Subject: FW: F/23/96606 Land rear of 12 Sydney Avenue, Hamble le Rice, SO31 4JP - Landscape Comments

Landscape Comments:

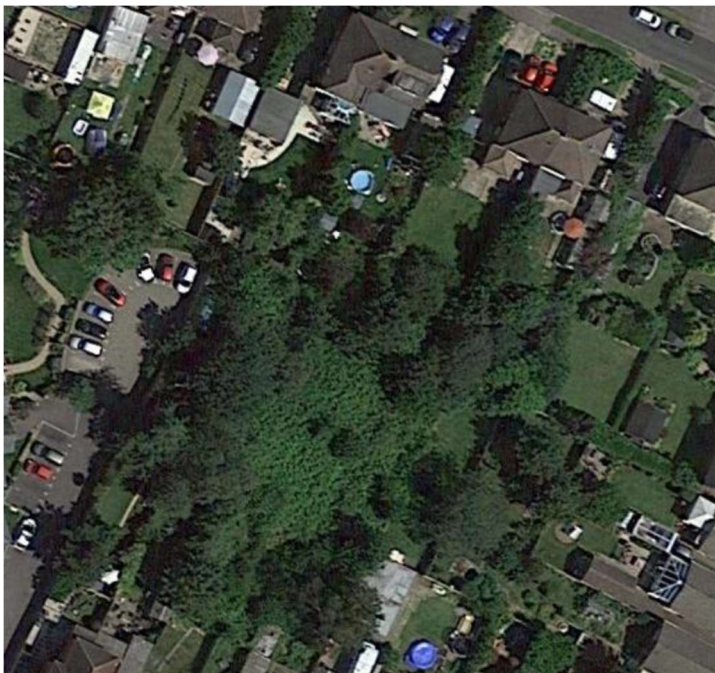
I note the EBC Ecologists comments regarding the extensive removal of existing vegetation for this latest application. Previous applications described the site as 'heavily vegetated and containing trees'. Google images clearly show a matrix of existing established vegetation on this site:

It is highly regrettable that the site has been cleared with the loss of significant habitats and visual amenity. To balance this loss we will be looking for deliverable Green Infrastructure.
